AGENDA

September 15, 2011 Standards Committee Meeting

RE: Agenda for the September 15, 2011 Standards Committee Meeting

PROPOSED RECURRING PLAN DETAILS 805-T-1XX MICROLOOP DETECTOR PROBES CROSS SECTION DETAIL

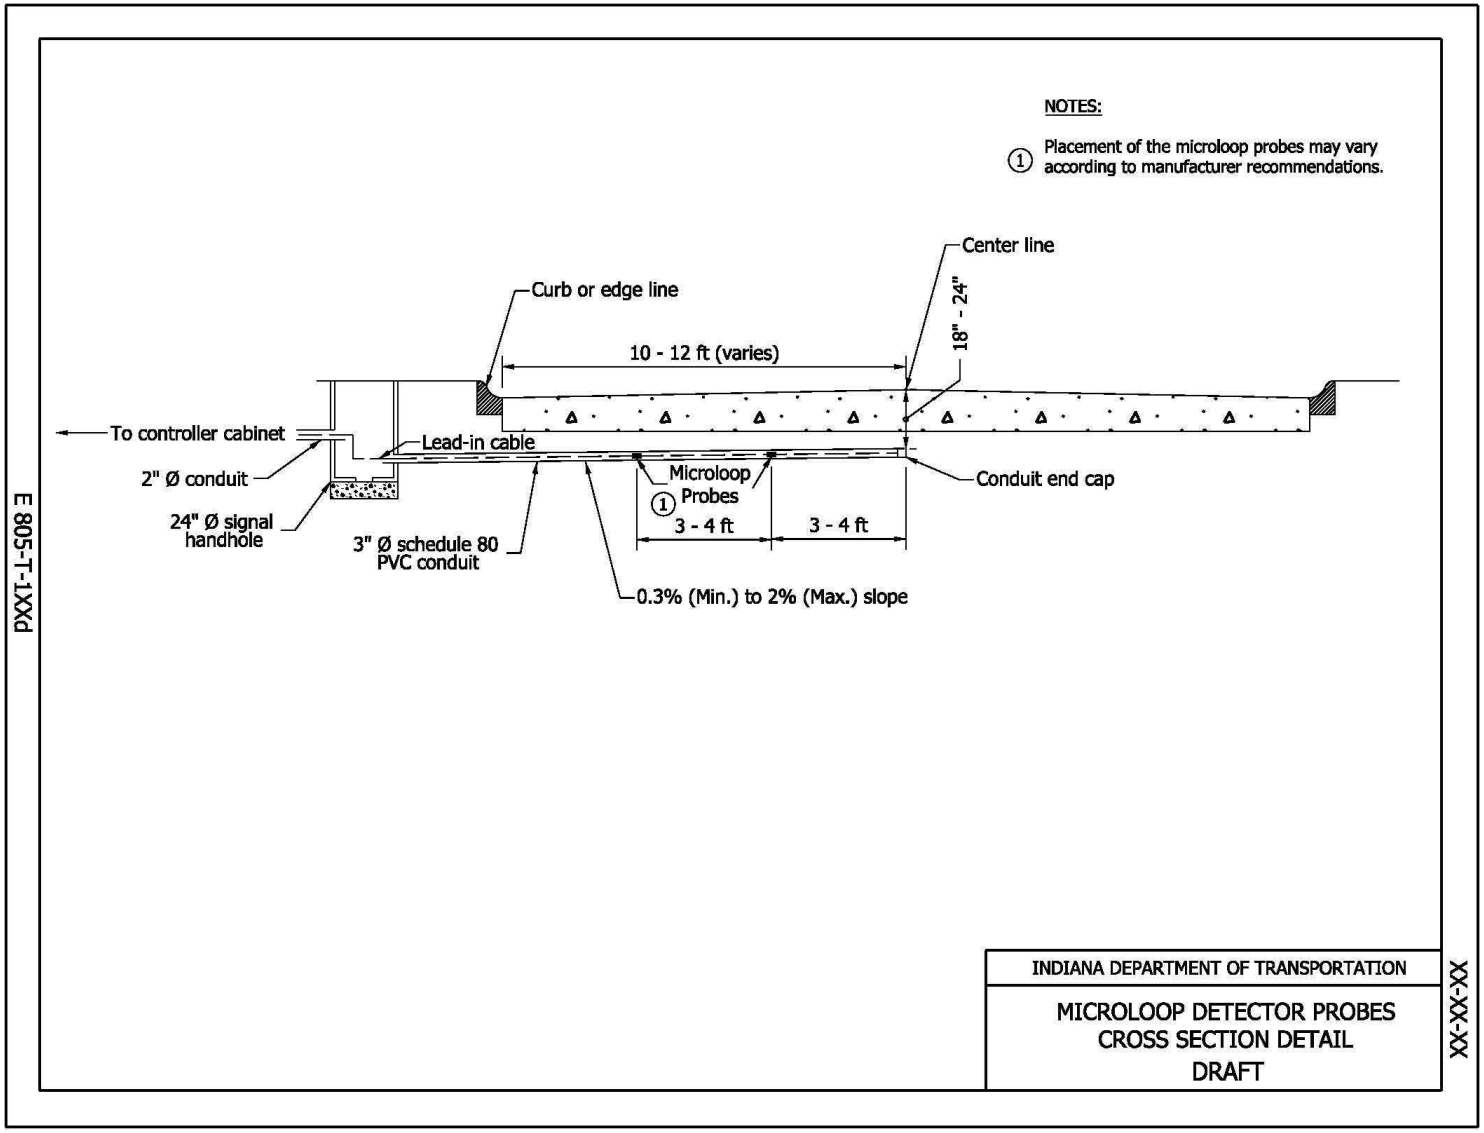
PROPOSED SOLUTION: Microloop detectors make it possible to install vehicle detection on an approach without cutting loops in the pavement. The microloops are installed in 3" diameter PVC conduit that is bored underneath the pavement from one side across to the other side. The microloop probe sets are wired in series to a traffic monitoring card or controller. Detection is achieved by monitoring the changes in the Earth's magnetic field caused by a passing vehicle. The development of a recurring plan detail and revisions to existing recurring special provision 805-T-169 and 922-T-168 will ensure that the system is constructed properly when specified.

PVC conduit for the microloop detector probes shall be directionally pushed beneath the pavement at the depth and slope determined by the manufacturer to ensure proper carrier and probe installation. The Contractor shall repair any damage to the pavement that occurs during the installation. The microloop detector probe location in each lane shall be per the manufacturer's recomendation.
